VOL. 14 No. 2

JANUARY 15, 1940

START THE OWNER RIGHT

PROPER USE OF HEATER SWITCH

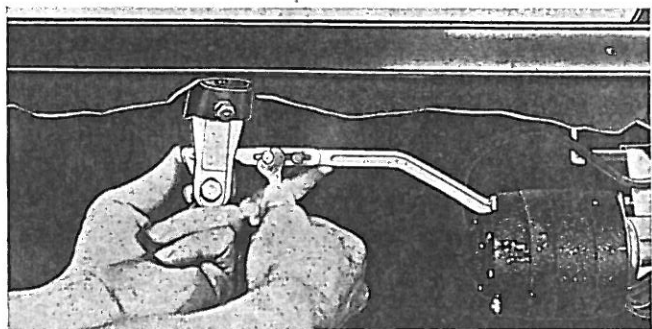
We believe in some cases Packard drivers are not getting the maximum efficiency out of our present dash heaters, due to not being entirely familiar with the operation of the heater switch.

With each heater we supply an instruction card with a note to "Hang this tag on switch knob" when the heater is installed. In many cases this is not being done. Please instruct all new car and service salesmen on the use of this switch and see that the instruction card is placed on the heater switch when the car is delivered. When the switch is turned one notch to the left the heat is blown from the front of the heater in the conventional manner. This delivers the maximum amount of heat with minimum defrosting. For less heat turn switch to second notch. Maximum defrosting and indirect heating are obtained by turning the switch one notch to the right, which reverses the direction of the heat, throwing it from the back of heater—diffusing the warm air throughout the car. For less heat turn switch to second notch. Heater door should always be open—when heater is in use.
